Community Concerns about Traffic Congestion Associated with Stadium Shopping Centre Redevelopment

(Reference: Development Permit DP2016-0305)

Prepared by: Dr. John Rowse, PhD (Economics)
Dr. Wayne Davies, PhD (Geography)
Dr. Robert Dewar, PhD (Psychology)
Dr. Pat Muir, PhD (Psychology)

March 2016

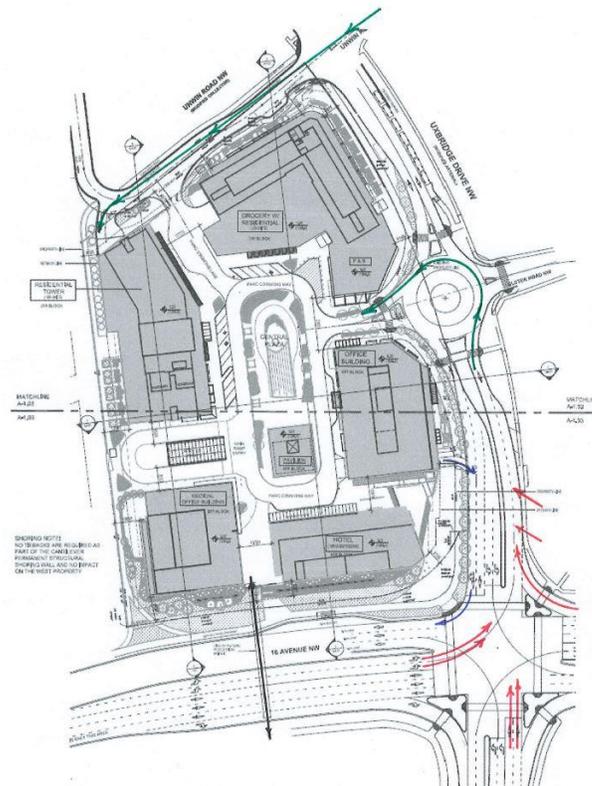
Depicted at the top of the image is a flow (in green) representing West Bound (WB) traffic along Unwin Road crossing Uxbridge Drive and then into the site at the northern entry point, directly into the underground parking

structure. Also depicted (in green) is traffic flow on the single North Bound (NB) lane on Uxbridge into the site at the roundabout, the main entry point.

Indicated in red are several possible traffic flows NB into UH from 29th Street and 16th Ave. There are two left-turn flows off 16th Ave into Uxbridge, two flows north on 29th Street, one flow WB from the right turn lane off 16th Ave, and two possible flows from the Tim Horton's/Shell station.

Not all flows NB onto Uxbridge (in red) can occur simultaneously, *but all flows must merge to a single lane to enter the roundabout*. The two flows from Tim Horton's/Shell station may enter Uxbridge regardless of the signal phasing of the traffic signal at the 16th Ave/Uxbridge intersection, but the right turn flow into Uxbridge will be subject to a yield sign. (To avoid collisions, right turn flows at present likely yield right-of-way even in the absence of a yield sign, so the presence of a yield sign is unlikely to alter future right turn flows much.) Two flows north from 29th St or two left-turning flows from EB 16th Ave to Uxbridge will, depending on the signal phasing, enter the two lanes north on Uxbridge which almost immediately merge into a single lane. If the two twinned flows north or from the EB left-turn lanes are continuous or nearly so, then traffic turning right off 16th Ave may find it difficult to turn right onto Uxbridge, slowing or halting following traffic. At peak travel times this combination of flows may cause traffic to back up to the 16th Ave intersection. Any stoppage of traffic on 16th Ave is a major safety concern.

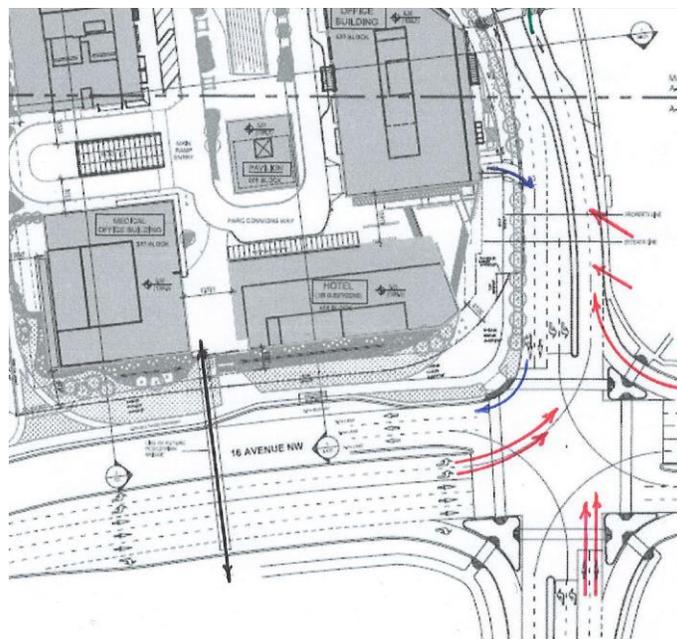
Referring to the image below (the bottom right of the very first image above), the proposed parkade exit SB onto Uxbridge may also generate slowdowns/stoppages as vehicles emerging from the exit (indicated in blue) intending to turn left onto 16th Ave move at least two lanes east to enter a turn lane. They may have to cross the paths of vehicles SB on Uxbridge emerging from the roundabout, congesting that traffic.

In addition, drivers presently turning right onto 16th Ave from Uxbridge utilize the turn lane of an existing “pork chop” at the northwest corner of the intersection. They can follow a traffic lane which extends nearly to Shaganappi Trail, allowing them much time to merge onto WB 16th Ave. In the DPA the “pork chop” has been removed (see the turning flow in blue above) and hence drivers on SB Uxbridge intending to turn right will have to wait until the stoplight allows them to do so or they are able to turn “right on red”. During the afternoon peak travel period, turning right when allowed by the traffic signal may be slowed by large numbers of pedestrians using the north-south pedestrian crosswalk on the west side of the intersection, and turning “right on red” may be difficult or impossible when WB traffic on 16th Ave crossing the intersection is so heavy that few opportunities arise to merge safely with that traffic. Opportunistic “right on red” turns by impatient drivers may also present safety concerns. The result is that traffic may build in the west traffic lane of SB Uxbridge, interfering with the smooth flow of traffic south of the roundabout, from the parking structure exit to Uxbridge and from north of the roundabout. Removal of the parkade exit onto Uxbridge and reinstatement of the “pork chop” is requested.

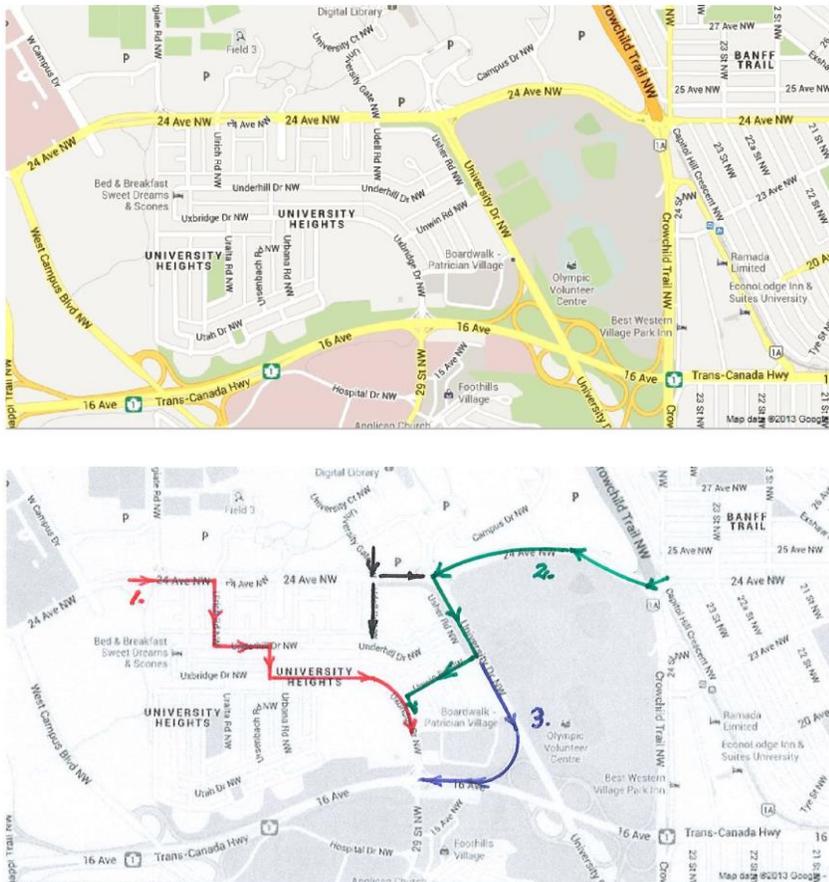
The DPA does not provide for a bus lay-by on Uxbridge. With only a single lane of traffic into the roundabout, the absence of a lay-by will significantly impede following South Bound (SB) vehicle traffic when a SB bus stops north of the roundabout. Although WS suggested that a stopped bus would likely entail a delay of only 20 seconds or so for vehicles following the bus, this time estimate seems optimistic when prospective delays are caused by bus passengers entering or exiting using walkers or wheelchairs or strollers or with bicycles, at times in the morning and afternoon when students from the adjacent school enter or exit, or if high-passenger-volume articulated buses ever travel on Uxbridge.

Further, retaining the bus stop for NB buses at its present location on Uxbridge (with no lay-by) will delay traffic NB on Uxbridge to the roundabout. It is worth noting again that, for Uxbridge just north of 16th Ave, the Final TIA projected a 39% increase in both-way traffic which, combined with the elimination of one of the two lanes approaching the roundabout, results in reduced safety for pedestrians and cyclists, increasing delays for transit and emergency vehicles, and degrading access for vehicles to SSC and UH.

At present, the #20 bus travels Uxbridge (north or south) every 10 minutes or so during the afternoon peak demand period, suggesting the frequency with which this particular traffic congestion may occur.

Bus lay-bys on both NB and SB Uxbridge at the SSC site are requested.

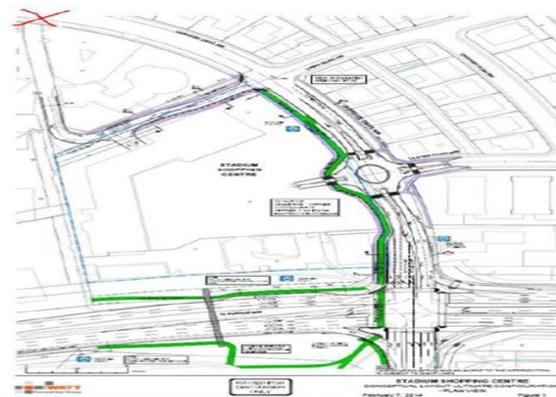
The image below depicts the possible location of a pedestrian crossing (with a red X) at the laneway/Uxbridge junction. Such a pedestrian crossing would facilitate pedestrian/bicycle traffic using the north-south connector from Uxbridge to Underhill (not shown in the image). There was no discussion of this possibility in the SSC Final TIA or in the ARP, and the community is unaware of any present plan to construct such a pedestrian crosswalk.

Already much pedestrian traffic across Uxbridge occurs at this location by Charter school students and persons walking to and from UC. Further, following SSC redevelopment the connector from Uxbridge to Underhill is likely to become heavily used by pedestrians/cyclists transiting between UC and SSC. A pedestrian crosswalk at this location is recommended following SSC redevelopment to improve safety for pedestrians/cyclists. However, if constructed, a pedestrian crosswalk will introduce a source of stopped traffic NB on Uxbridge, this time north of Unwin.
